ADDENDUM No. 2

March 30, 2016

Little Sisters of the Poor Main Street Renovations
601 Maiden Choice Lane, Baltimore MD 21228

Project No: 15046.00

PN: 15046.00	DATE: 03-30-16
Reference Dwg:	P-110
DWG. NO.	P-SK-110-01

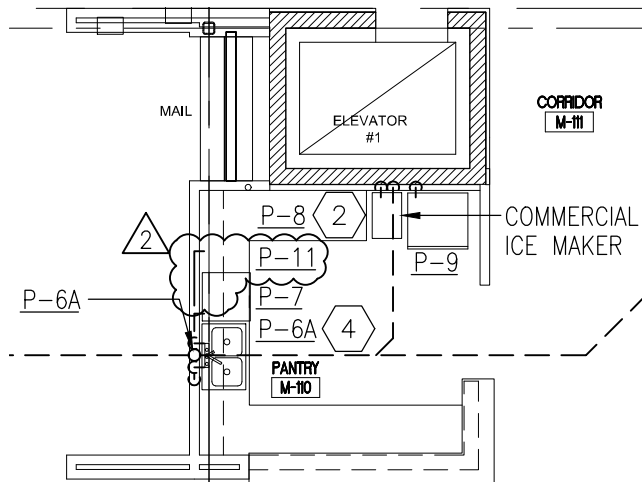
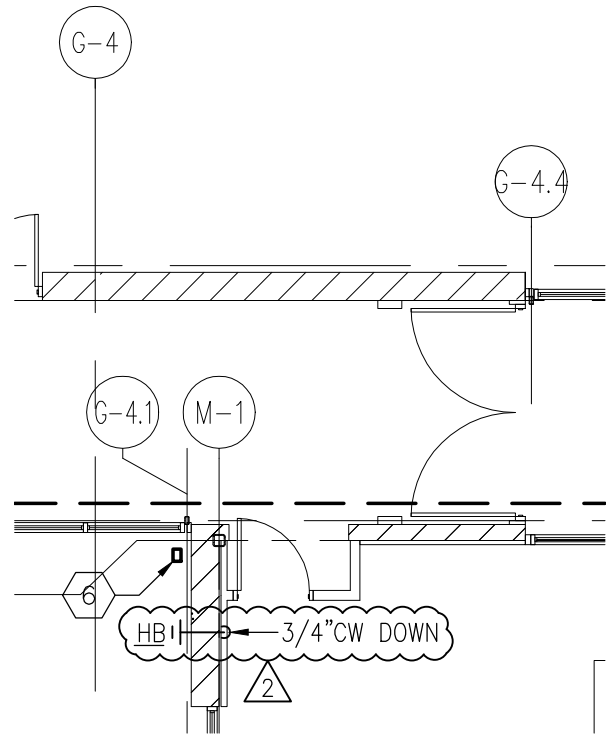
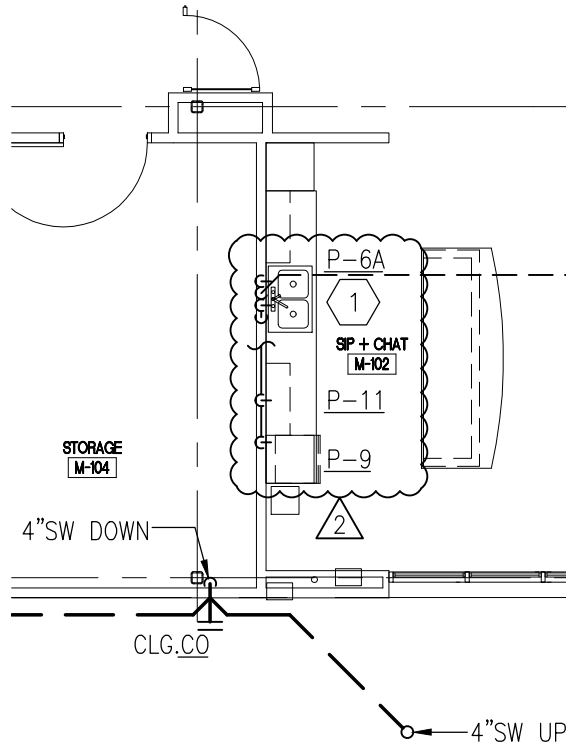
1. Drawing P-110: see attached sketch P-SK-110-01 for added court yard hose bib.
2. Drawing P-111: see attached sketch P-SK-111-01 for updates as follows:
 - a. Added water lines for coffee makers to Sip and Chat and Pantry.
 - b. Revised Sip & Chat sink to two-compartment sink.
 - c. Added hose bib to courtyard.
3. Drawing P-610: see revised drawing for updates to the Plumbing Fixture Schedule and the Sanitary Riser diagram
4. Drawing M-111: see attached sketch M-SK-111-01 for modified ductwork for FCU M-1 and FCU M-4.
5. Drawing M-611: see attached sketch M-SK-611-01 for revised zoning for Chaplain M-117 which is now zoned with the Library.
6. Drawing M-612: see attached sketch M-SK-612-01 for revisions to the Fan Coil Unit Schedule.
 - a. FCU M-1 and FCU M-4 have revised airflow quantities.

DWG. NO.
M-SK-611-01

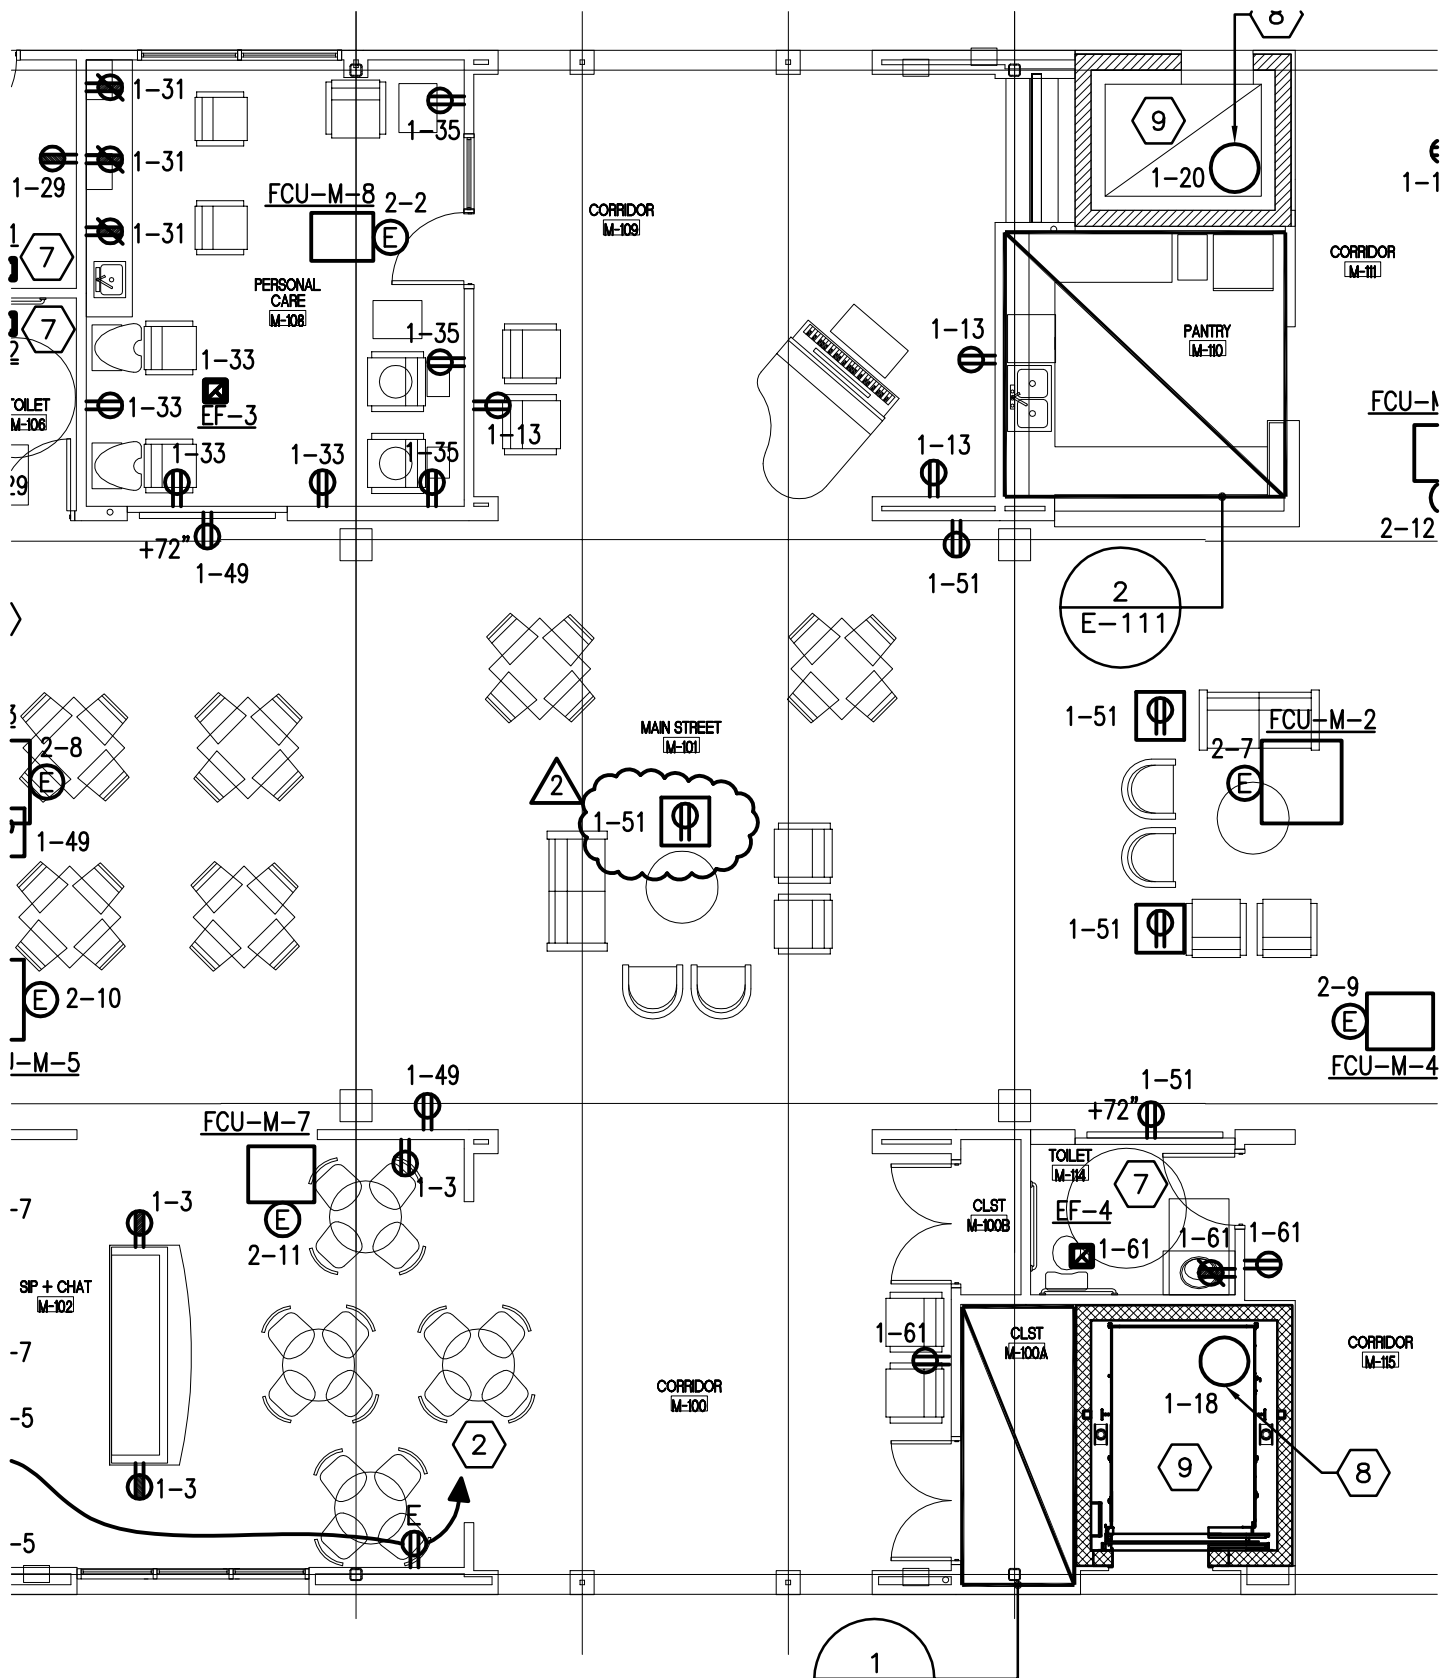
- b. FCU M-10 through FCU M-31 are Vertical Cabinets in lieu of Low Vertical Cabinets.

DWG. NO. E-SK-601-01

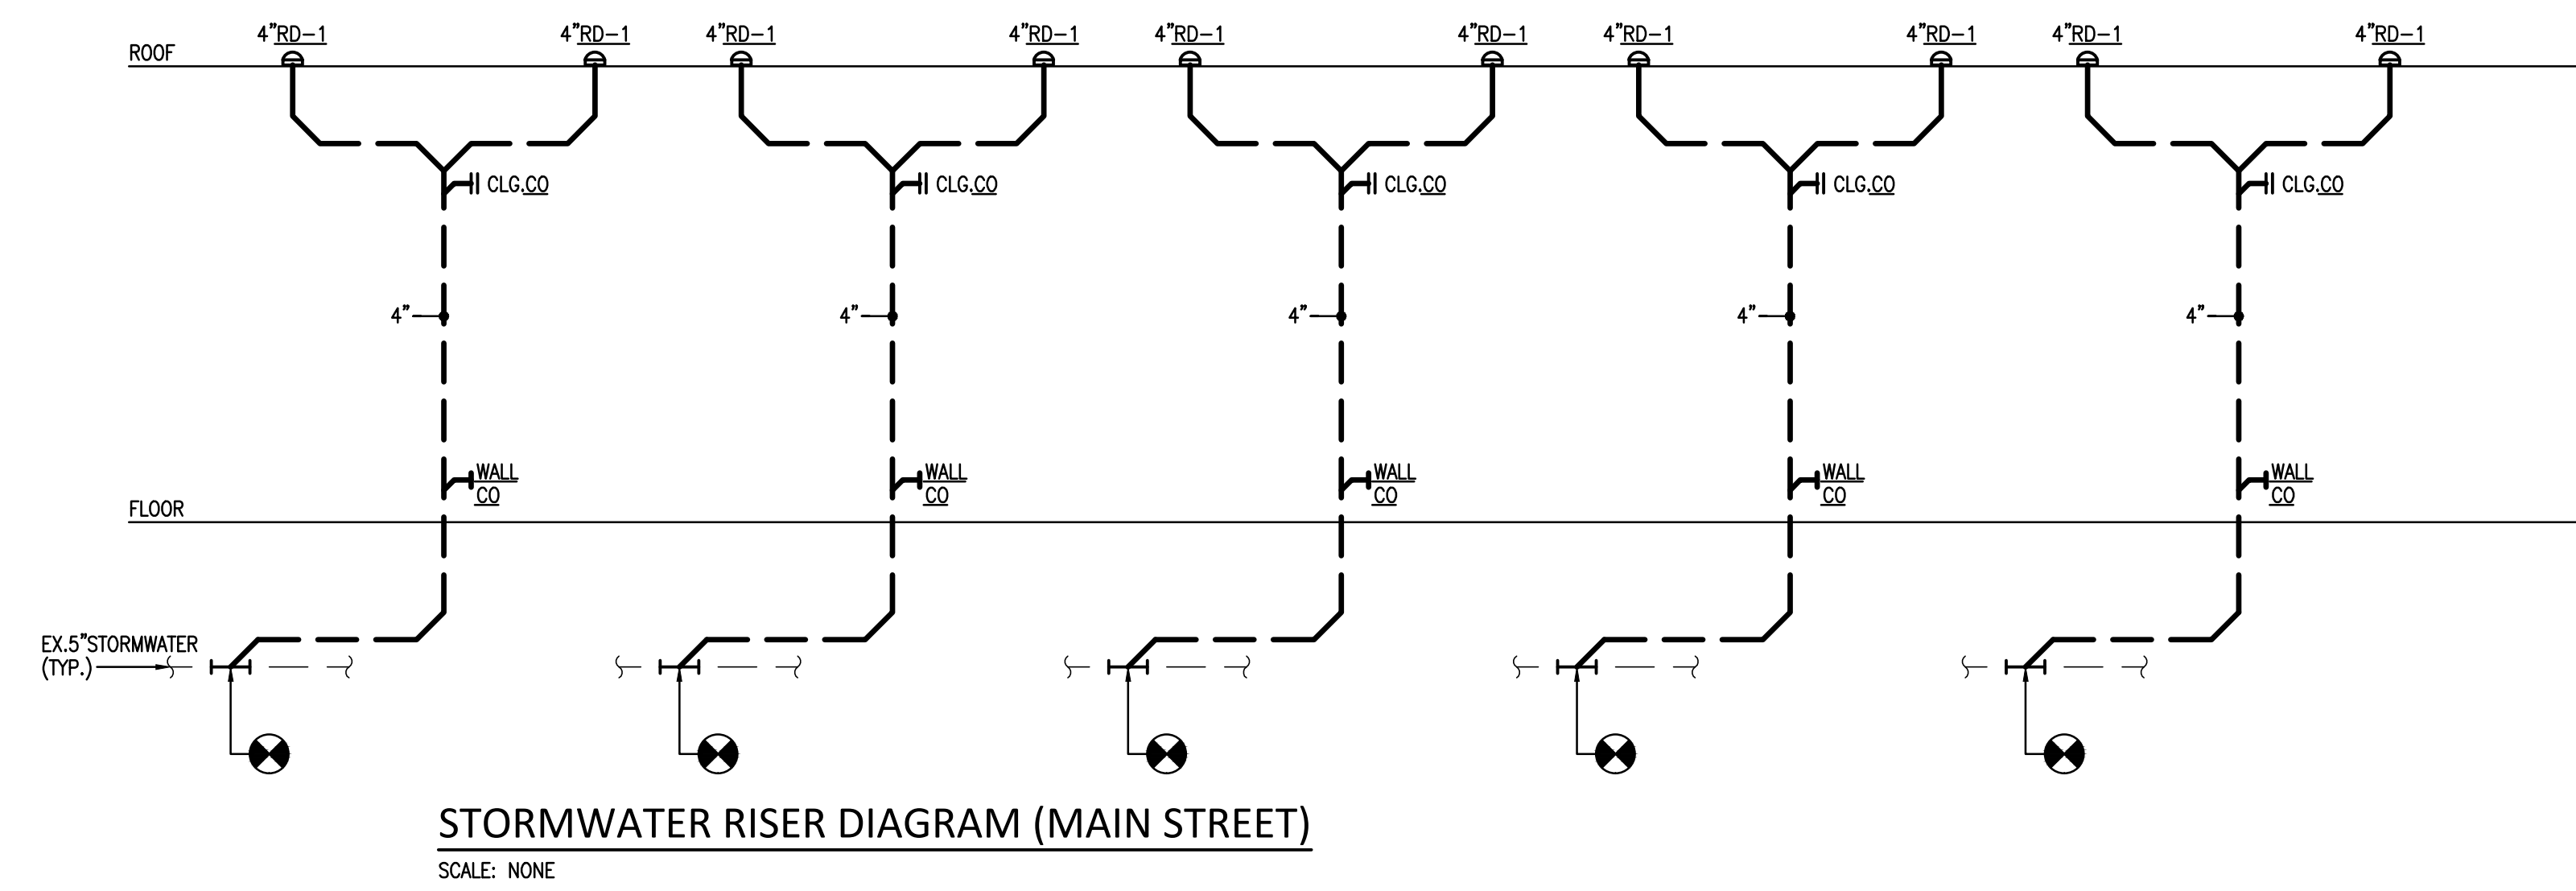
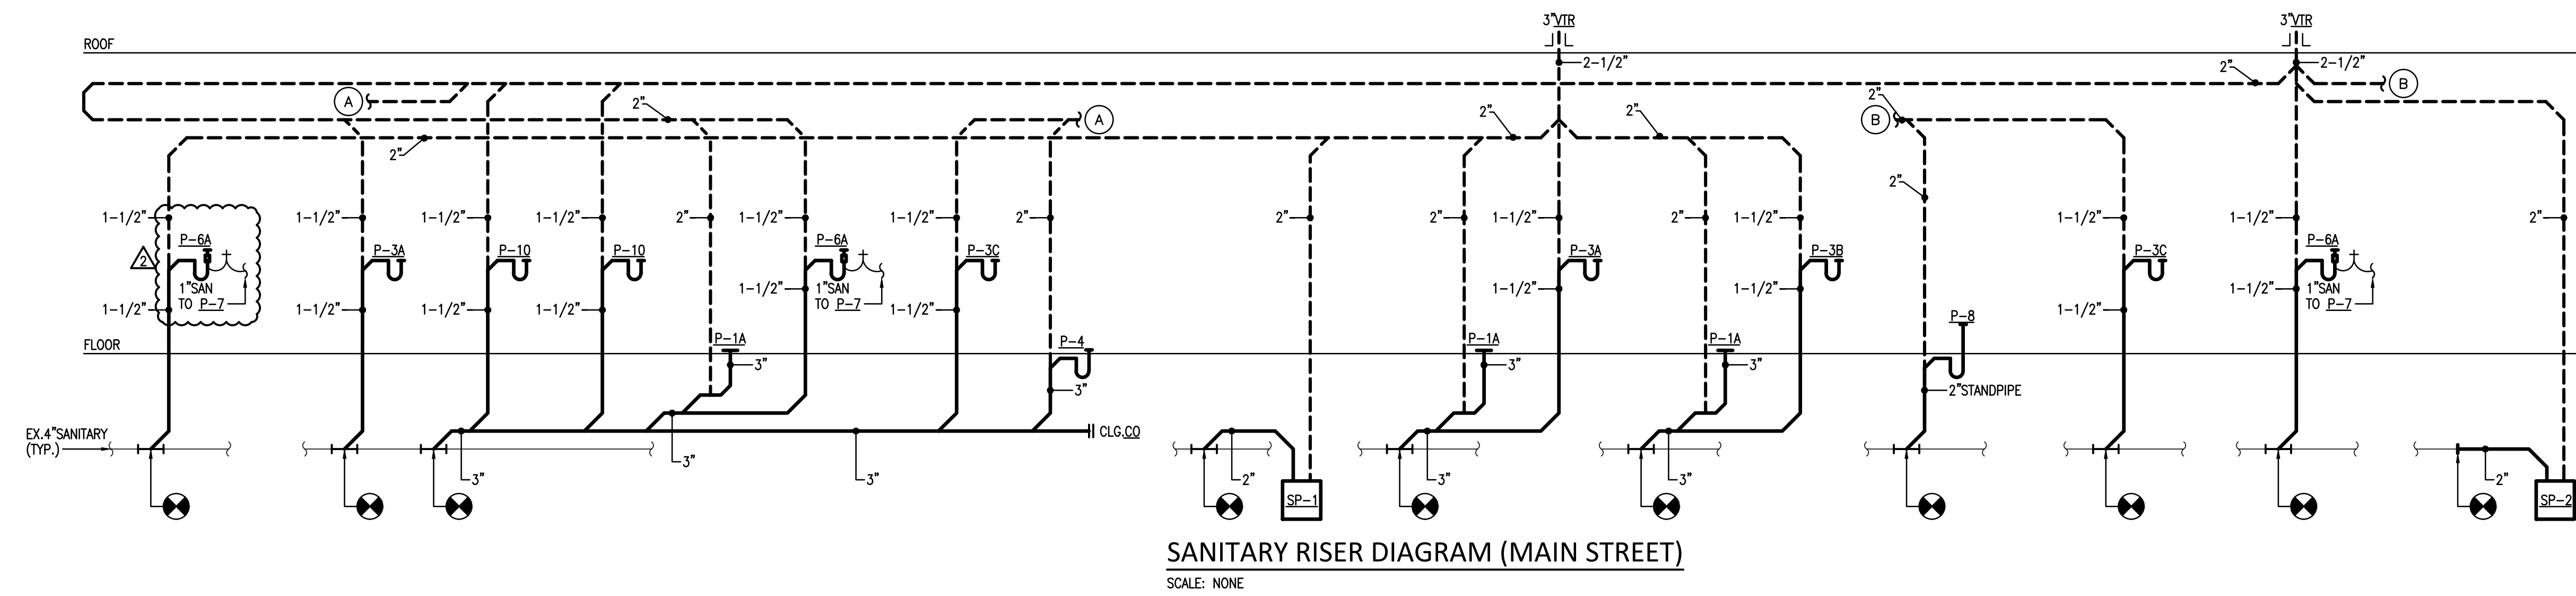
1. Drawing E-111: see attached sketch E-SK-111-01 for added floor receptacle in Main Street M-101.
2. Drawing E-211: see revised drawing for:
 - a. Updated lighting in rooms M-100, M-101, M-102, M-103, M-109, M-112 & M-116.
 - b. Added exterior lighting.
3. Drawing E-311: see revised drawing for:
 - a. Additional fire alarm devices in M-104 & M-108.
 - b. Additional telephone in north corridor.
- c. Drawing E-601: see attached sketch E-SK-601-01 for modifications to the lighting fixture schedule.
